FROM: Peter Johansson  
TO: T10 SBP-3 working group  
DATE: August 20, 2001  
RE: Stream ORBs: the fewer, the better

The following normative text is proposed for inclusion in a forthcoming SBP-3 working draft.

**Figure 18 – Stream command block ORB**

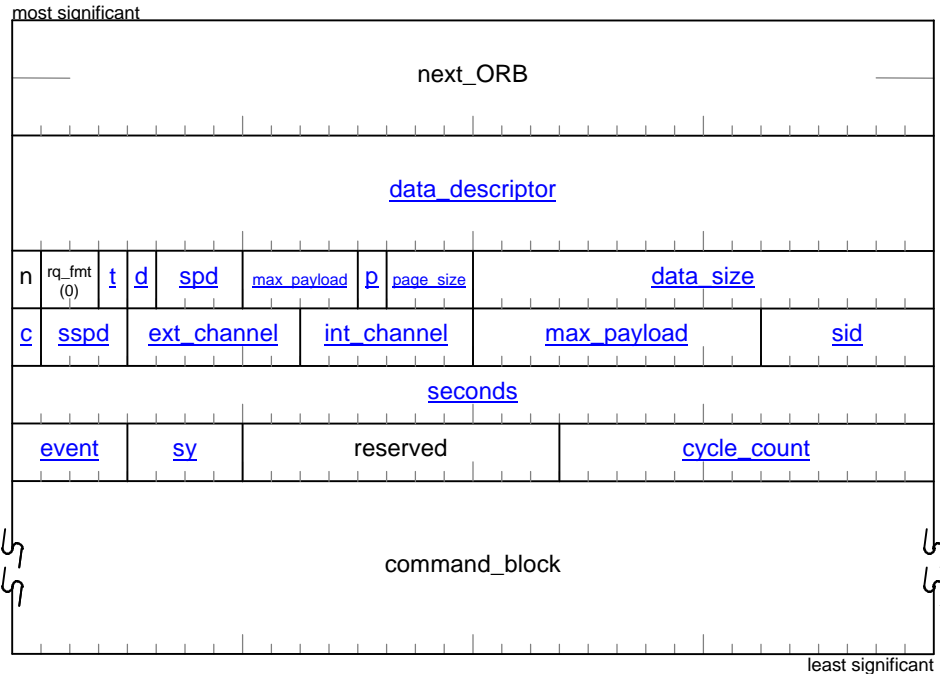
~~The *cm* field (together with the *cycle\_mark\_offset* field) specifies the location of the first quadlet of isochronous data (stream offset) as encoded by the table below.~~

~~The stream offset derived from the combination of *cm* and *cycle\_mark\_offset* specifies the location of the first quadlet of the isochronous data as an offset, in quadlets, relative to the starting medium location indicated by the *command\_block*. For a block device, the stream offset, expressed in bytes, shall be less than the block size of the device.~~

~~The *cycle\_mark\_offset* field, when *cm* has a value of two or three, specifies the location of the first CYCLE MARK packet as an offset, in quadlets, relative to the starting medium location indicated by the *command\_block*. When *cm* has a value of one, *cycle\_mark\_offset* specifies the stream offset instead. In either case, the value of *cycle\_mark\_offset*, converted to bytes, shall be less than *stream\_length*.~~

~~The *stream\_length* field specifies the length of data, in bytes, that is to be transferred to or from the device medium.~~

The *talker* bit (abbreviated as *t* in the figure above) specifies the direction of isochronous data transfer for the command contained within the ORB. When the *talker* bit is zero, data is received from Serial Bus but when the bit is one data is transmitted to Serial Bus.

The *ext\_channel* field shall specify the channel number observable in the stream's isochronous packets on Serial Bus. When *talker* is zero, the *ext\_channel* field provides a filter for packet reception. If *talker* is one, the field specifies the channel number transmitted in isochronous packets.

The *int\_channel* field shall specify the channel number used internally by the device for the stream's isochronous packets. Some devices (or some of their operating modes) do not use internal channel numbers, in which case the field is ignored. For other devices, the combination of *int\_channel* and *ext\_channel* specifies a transformation between internal and external (Serial Bus) channel numbers, dependent on whether the device is listening or talking. When the device is a listener, the observed channel number in the isochronous packet header shall be replaced with *int\_channel* as the data is recorded on the medium. When the device is a talker, the channel number obtained from the medium shall be replaced with *dest\_channel* at the time the isochronous packet is transmitted.

**Figure 19— Stream control ORB**

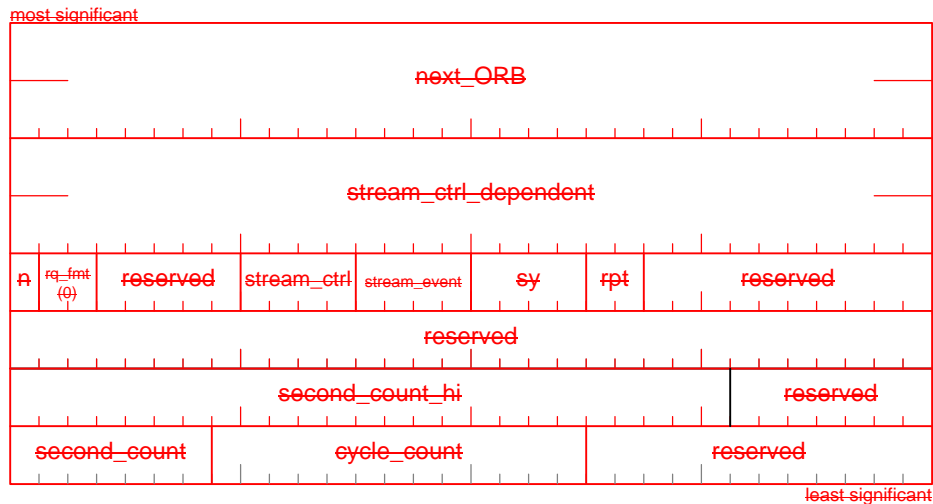
~~Stream control ORBs direct the action of a logical unit stream controller. The stream controller is configured at the time of a create stream request as either a talker or a listener. When listening, the stream controller accepts isochronous data from Serial Bus in accordance with stream control ORBs, transforms the isochronous stream and then records the data on the medium as specified by stream command block ORBs. When talking, this process is reversed and an isochronous data stream obtained from the medium is filtered and transformed by the stream controller before isochronous packets are transmitted on Serial Bus.~~

~~The format of the stream control ORB is illustrated below.~~

~~The *next\_ORB* field shall contain a null pointer or the address of a dummy ORB or a stream control ORB and shall conform to the address pointer format illustrated by Figure 12.~~

~~The usage of the *stream\_ctrl\_dependent* field varies according to the value of *stream\_ctrl* and is described in more detail for each stream control function.~~

~~The *notify* bit and *rq\_fmt* field are as previously defined for all ORB formats. The *rq\_fmt* field shall be zero.~~

Figure 27 – Create stream ORB

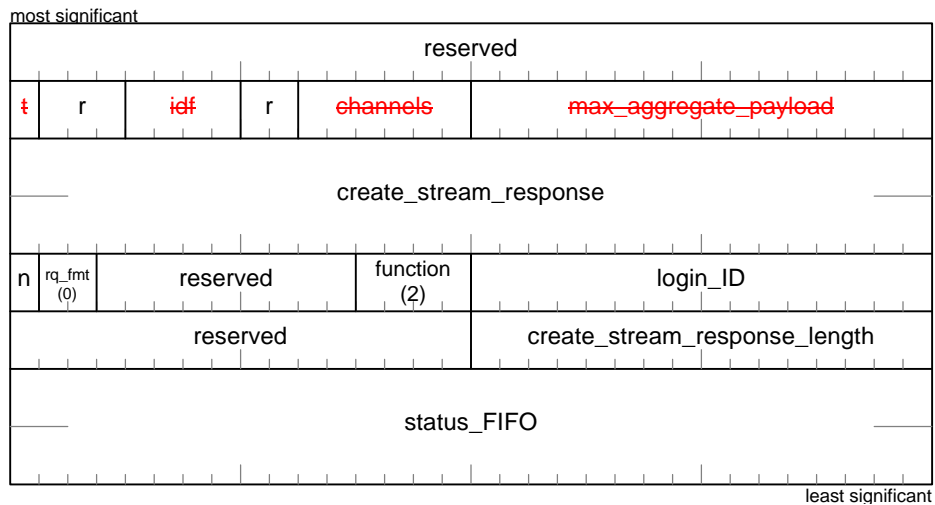
~~The talker bit (abbreviated as *t* in the figure above) shall specify the type of isochronous stream requested. If the target resources are to be configured for listening, talker shall be zero.~~

**Figure 28 – Create stream response**

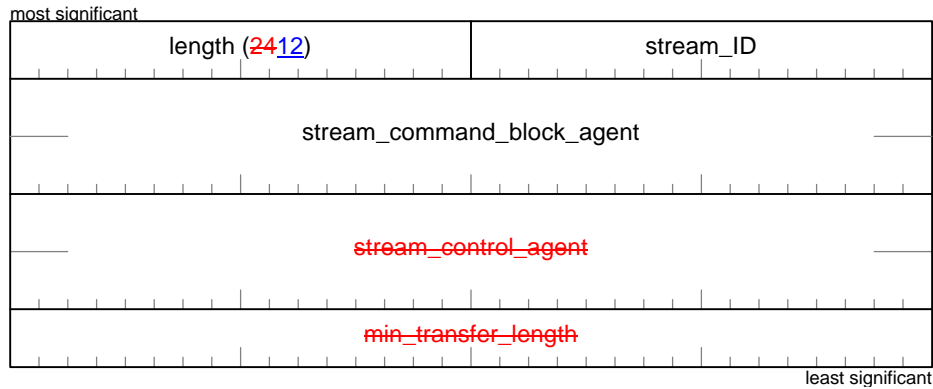
~~The *stream\_command\_block\_agent* and *stream\_control\_agent* fields specify the base address of the agent's CSRs, which are defined in 6.4. Both fields shall conform to the format for address pointers specified by Figure 11. The *node\_ID* portion of either field shall have a value equal to the most significant 16 bits of the target's NODE\_IDS register. If the target does not implement a stream control agent, the contents of *stream\_control\_agent* are unspecified and shall be ignored by the initiator.~~

~~The *min\_transfer\_length* field advises the initiator of the minimum *stream\_length* value desired by the target in stream command block ORBs in order to sustain the isochronous data transfer rate requested by the login. If the initiator presents any stream command block ORBs whose *stream\_length* value is less than this minimum, the target may experience underflow or overflow in isochronous data while talking or listening at the requested rate. Even if this minimum is respected it is still possible for underflow or overflow to occur.~~

**Figure 31a – Stream control ORB**

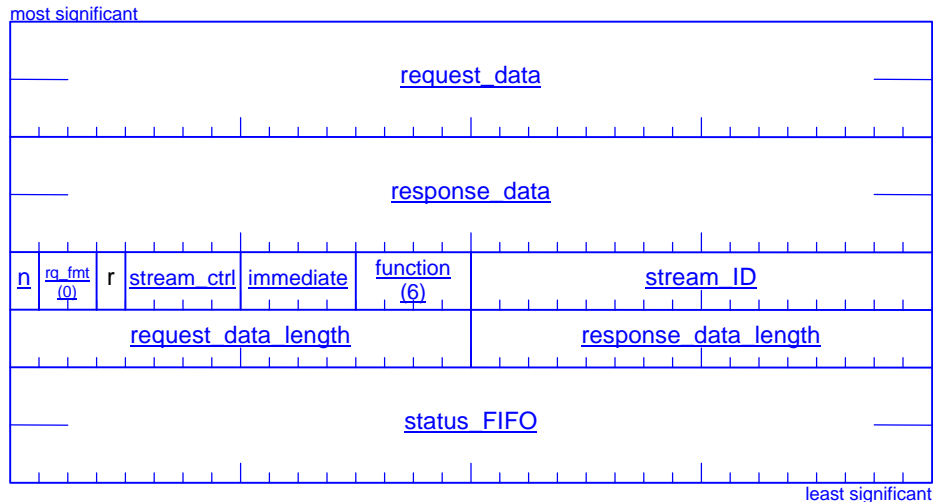
The stream control ORB permits characteristics of a target stream controller to be interrogated or established. The format of this management ORB is shown below.

The *request\_data* and *request\_data\_length* fields specify the address and size, in bytes, of a buffer allocated for optional request data pertinent to the stream control operation. The *request\_data* field shall conform to the format for address pointers specified by Figure 11 and shall address the same node as the initiator; consequently the *node\_ID* field of this address pointer is reserved. The buffer shall be accessible to a Serial Bus block read request with a data transfer length less than or equal to *request\_data\_length*.

The *response\_data* and *response\_data\_length* fields specify the address and size, in bytes, of a buffer allocated for the return of optional response data that results from the stream control operation. The *response\_data* field shall conform to the format for address pointers specified by Figure 11 and shall address the same node as the initiator; consequently the *node\_ID* field of this address pointer is reserved. The buffer shall be accessible to a Serial Bus block write request with a data transfer length less than or equal to *response\_data\_length*.

The *stream\_ctrl* field shall specify a stream control function for the stream, as encoded below.

<u>Value</u>	<u>Stream control function</u>
<u>0</u>	<u>Reserved; not to be used</u>
<u>1</u>	<u>CONFIGURE CHANNELS</u>
<u>2</u>	<u>SET ERROR MODE</u>
<u>3 – F<sub>16</sub></u>	<u>Reserved for future standardization</u>

**Figure 31b – Stream control request / response buffer format**

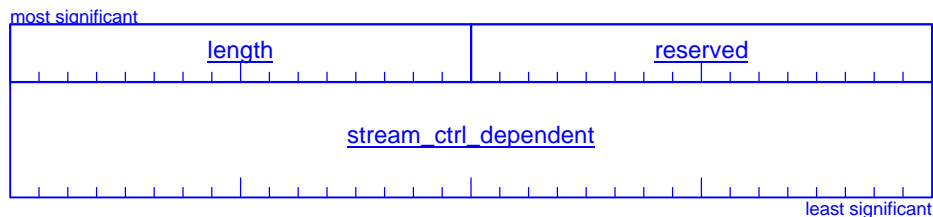
Both stream control request and response data use the same basic format, illustrated by Figure 31b below.

The *length* field shall contain the length, in bytes, of the request or response data. If the stream control operation fails, the contents of the response buffer are unspecified. Otherwise, upon successful completion of the stream control operation, the target shall store response data up to the length specified
